CLEVELAND NATIONAL FOREST POWER LINE REPLACEMENT PROJECTS

MINOR PROJECT REFINEMENT REQUEST FORM

SDG&E requests the following refinements along TL629A:

**Attachment B:
Comparison Map
TL629A Map 1 of 2**

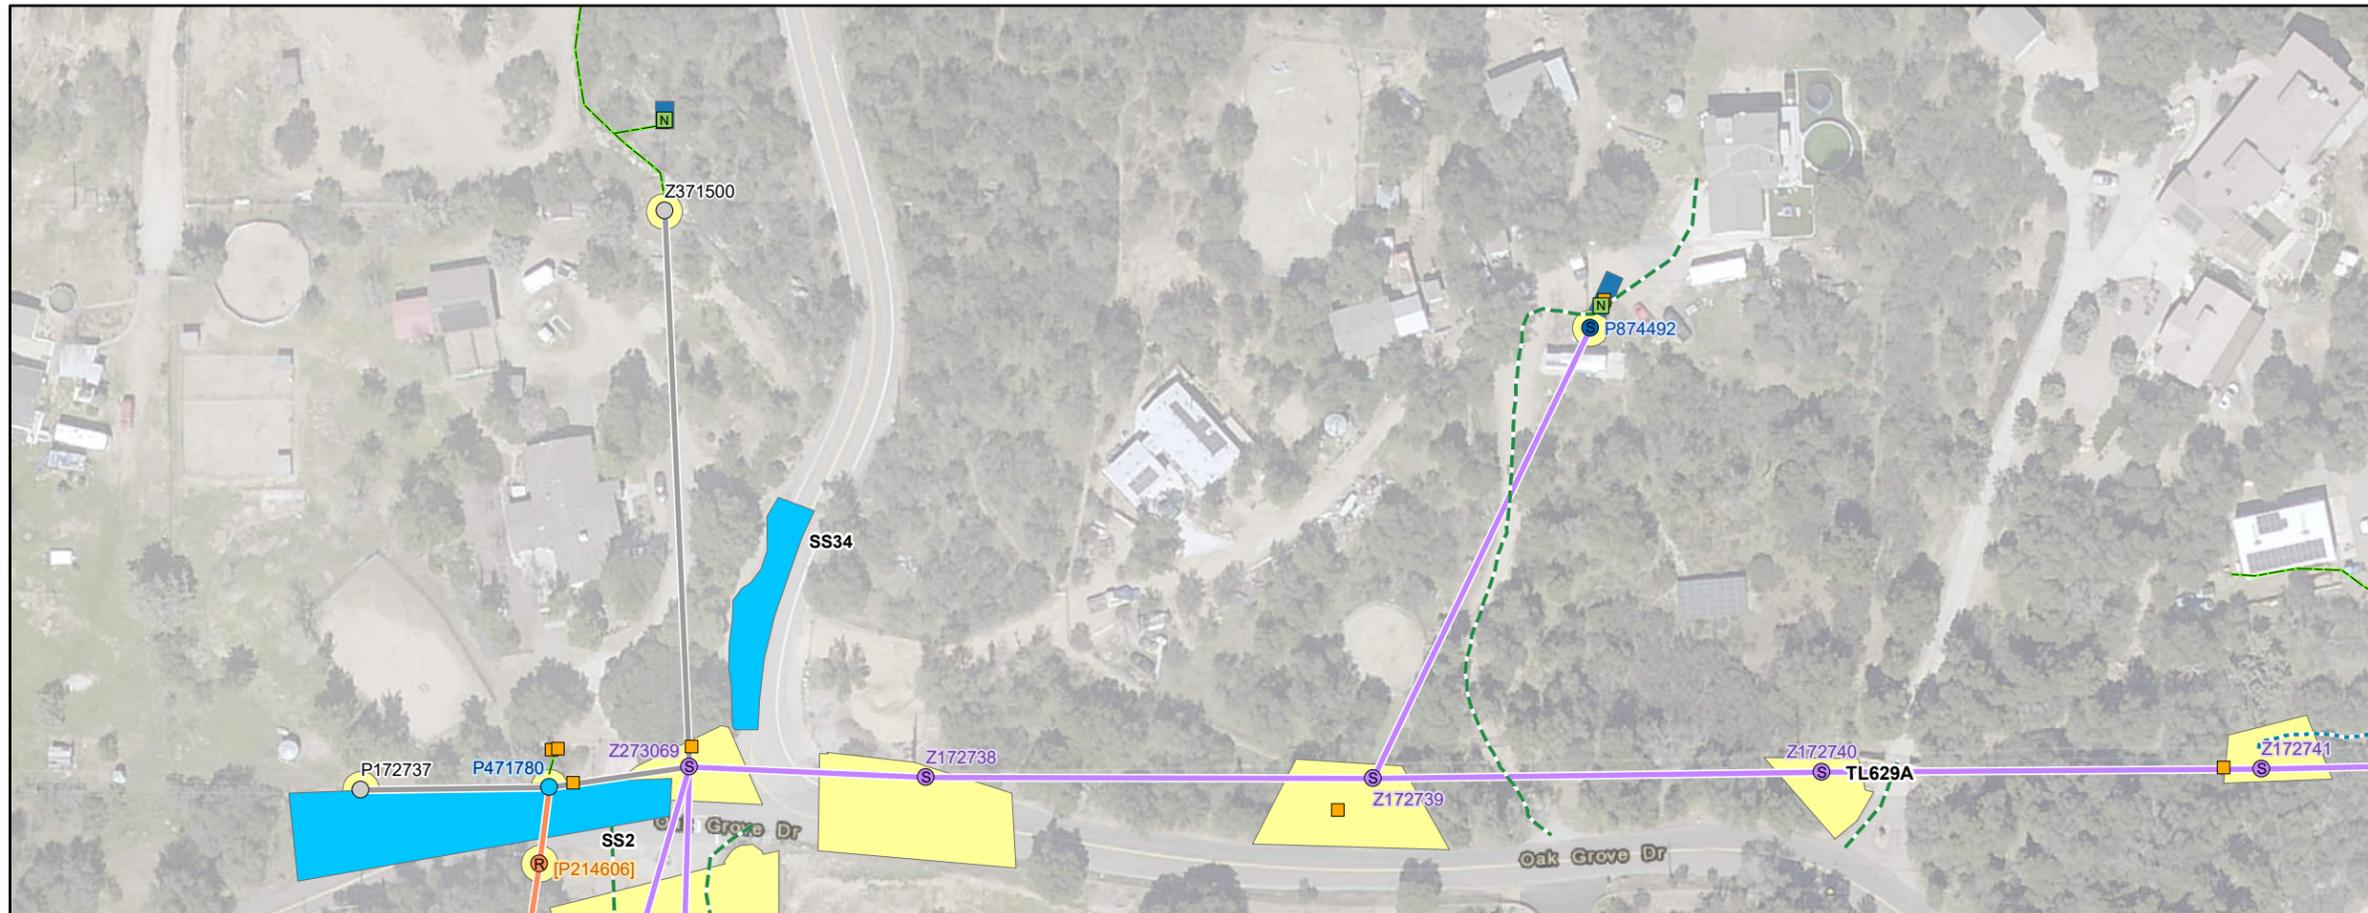
- shifting of the replacement pole location for Pole P874492 and the associated new anchor by approximately 36 feet southwest, as well as the addition of new temporary pole work area and anchor work area;
- addition of 36 feet of new undergrounding from the removal pole location for Pole P874492 to the new replacement location and new underground temporary work limits;
- shifting of the replacement pole location for Pole Z172739 by approximately 14 feet west, as well as the addition of approximately 183 feet of construction-only access road¹ and new temporary pole work area; and
- addition of two new steel distribution poles for a pole-mounted 12 kilovolt regulator station and new temporary pole work area, as well as the establishment of approximately 82 feet of permanent maintained access road.

- The landowner requested that the replacement pole location for Pole P874492 be shifted away from the existing pole location to be further from the house and driveway. As a result, the new anchor associated with the pole also needs to be shifted and new temporary pole work area and anchor work area need to be added. Because the pole is a distribution riser pole, the pole shift requires new underground distribution line to be trenched from the new pole location to the existing underground conduit at the existing pole location and underground temporary work limits to be added.

- The landowner requested that the replacement pole location for Pole Z172739 be shifted away from the existing pole location to avoid removal of manzanita bushes (*Arctostaphylos* spp.). Use of the construction-only access road and the additional temporary pole work area will also reduce impacts to manzanita bushes and other vegetation within the temporary pole work area approved for Pole Z172739 in NTP #20.

**Attachment B:
Comparison Map
TL629A Map 2 of 2**

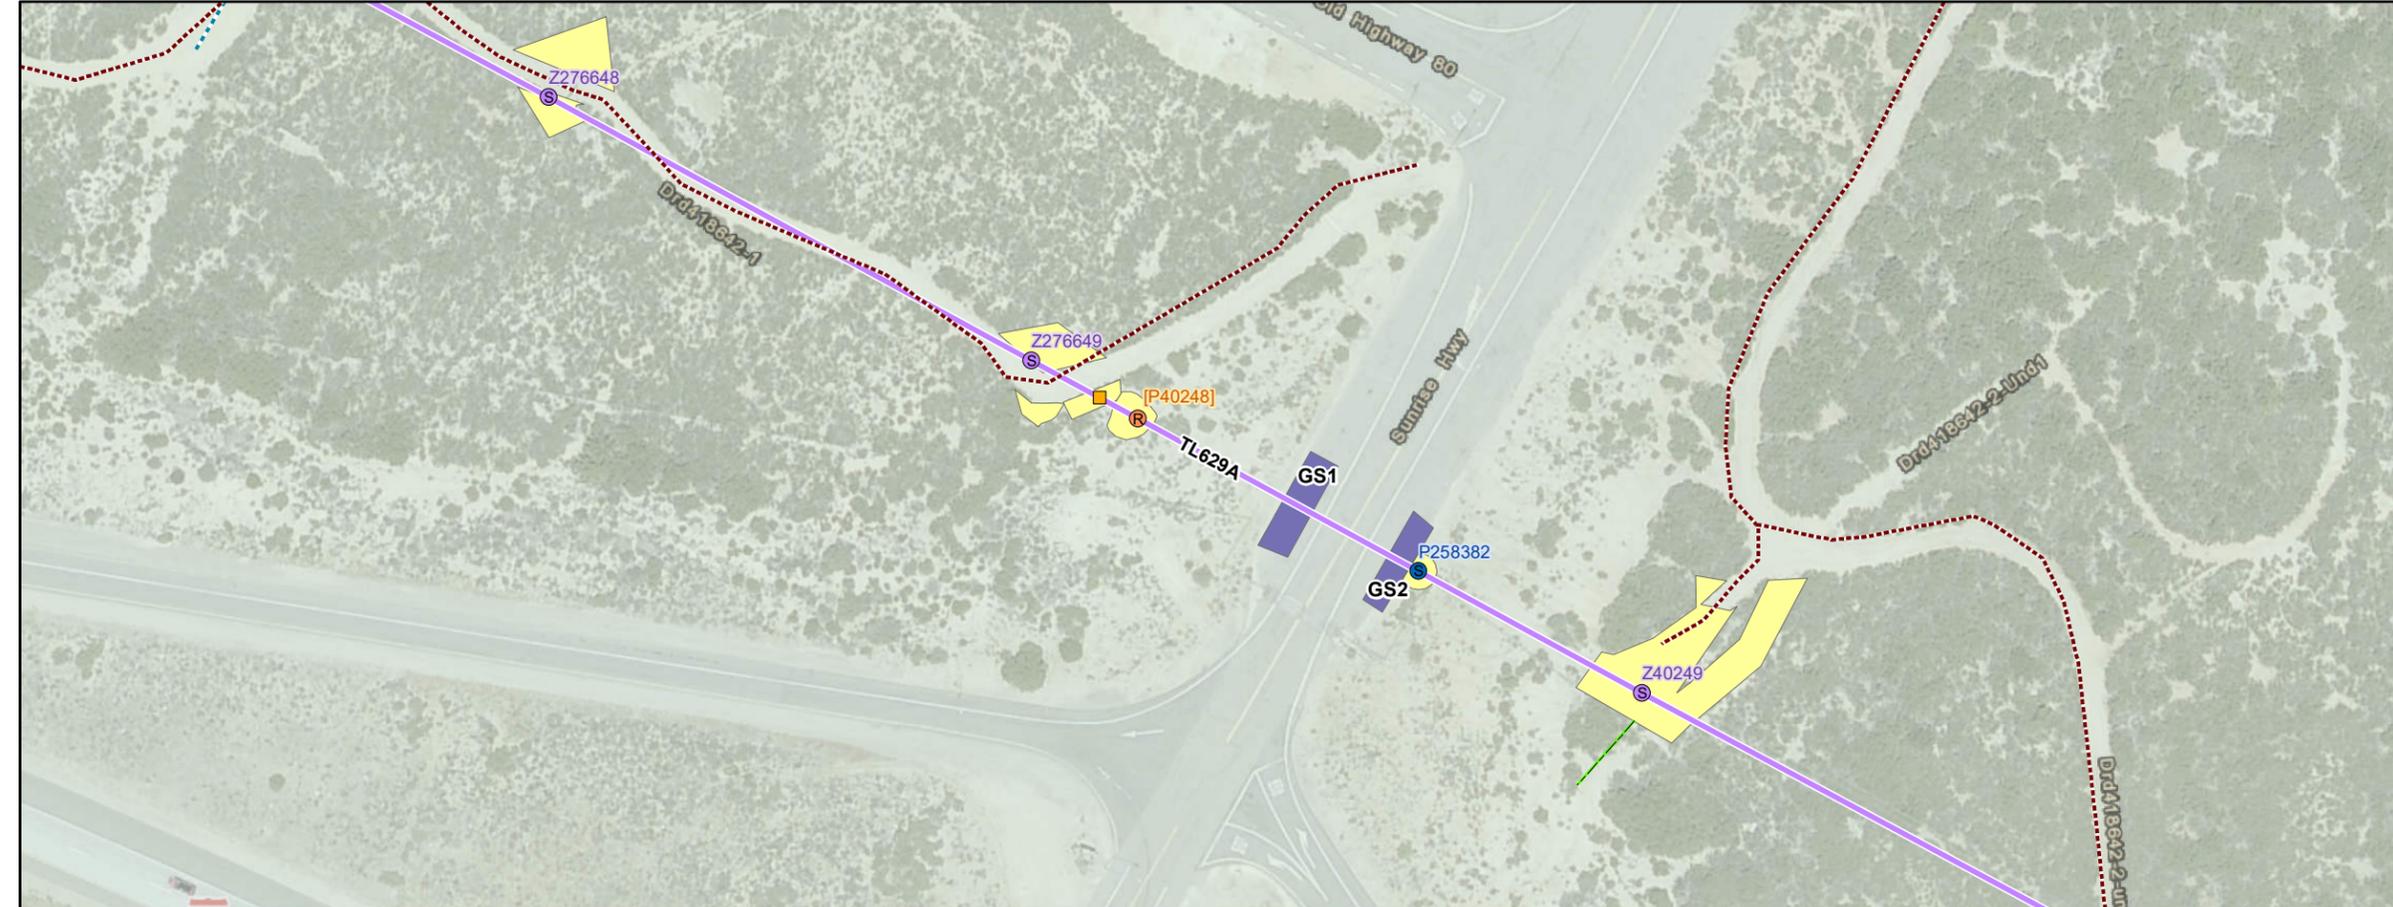
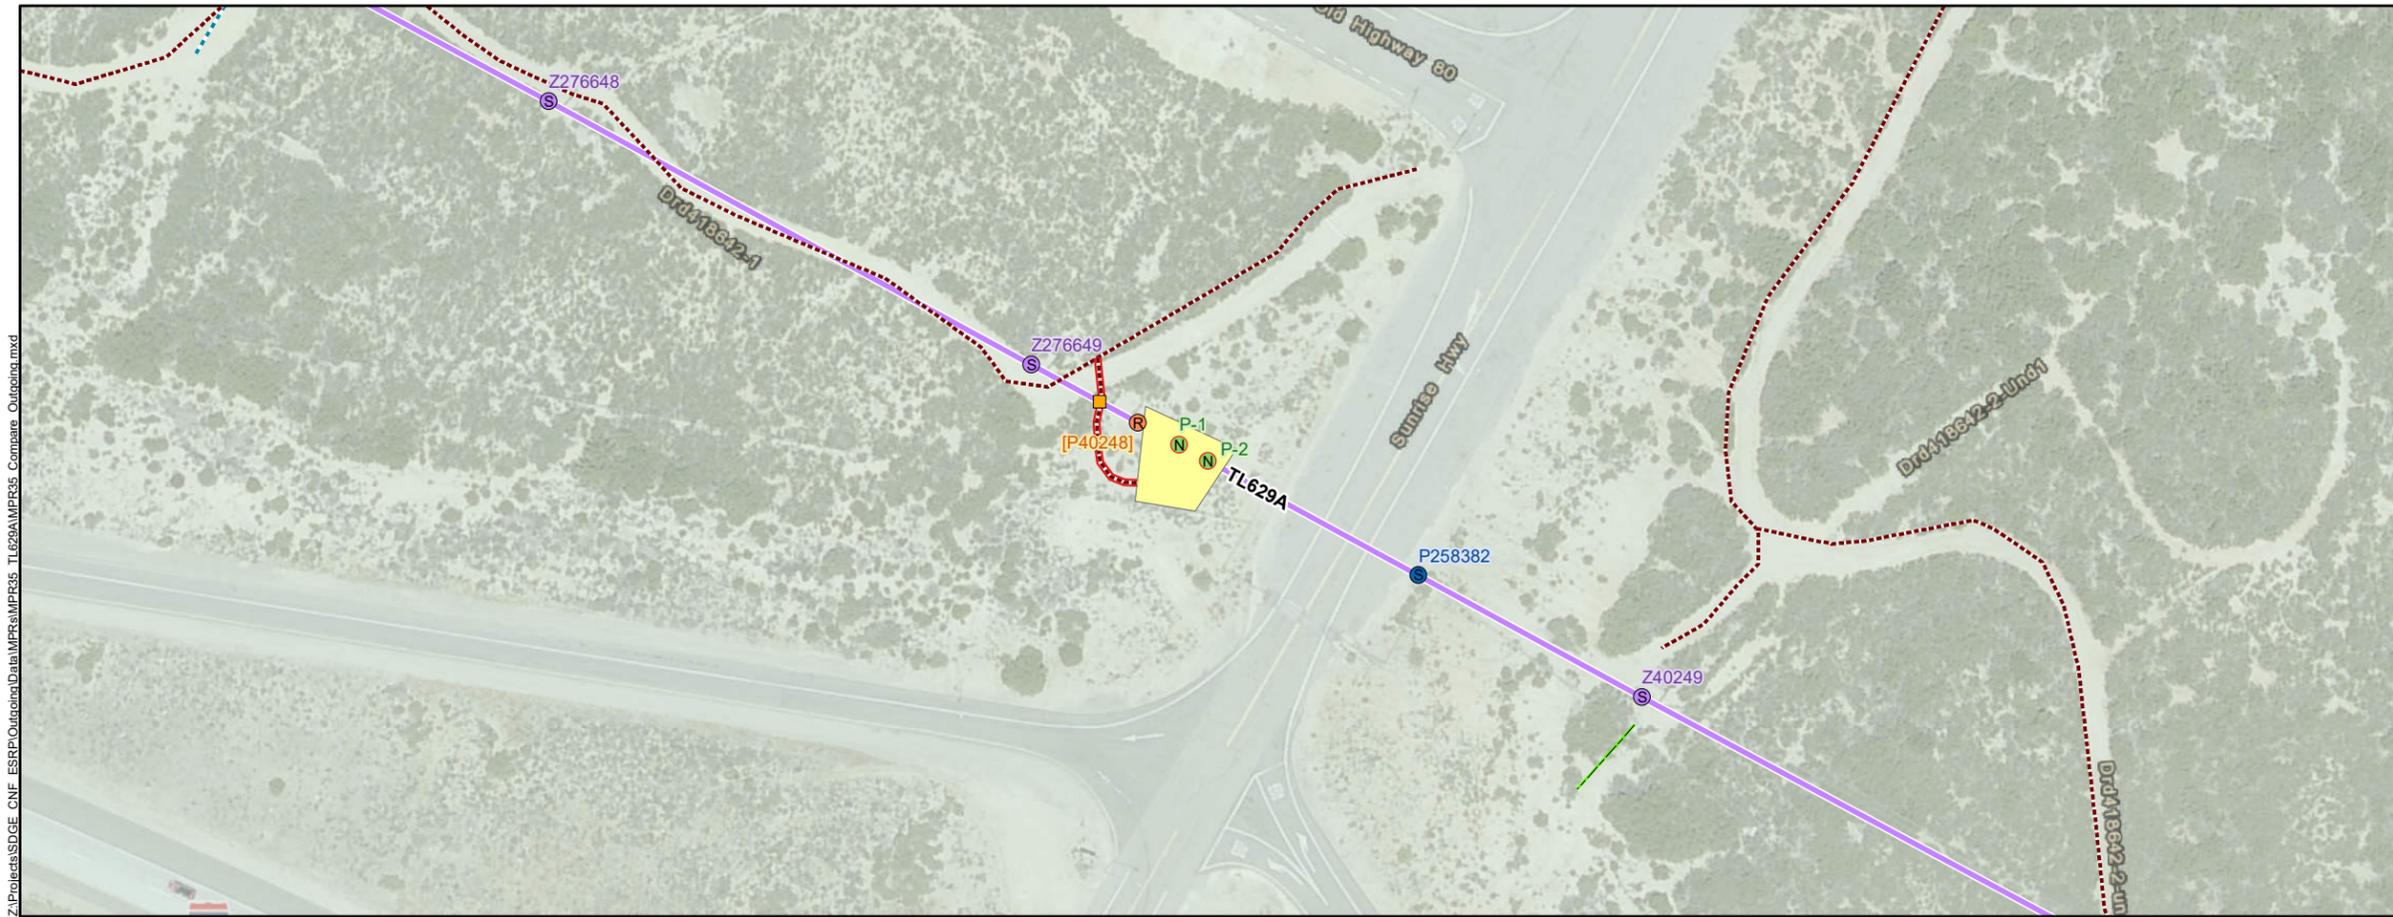
- The new regulator station was inadvertently left out of the final design, but is required for voltage management on Circuit (C) 440, which is underbuilt on TL629A, and C442. As a result, additional temporary pole work area is needed to facilitate construction, and a permanent maintained access road is needed to allow for operations and maintenance access to the regulator station.
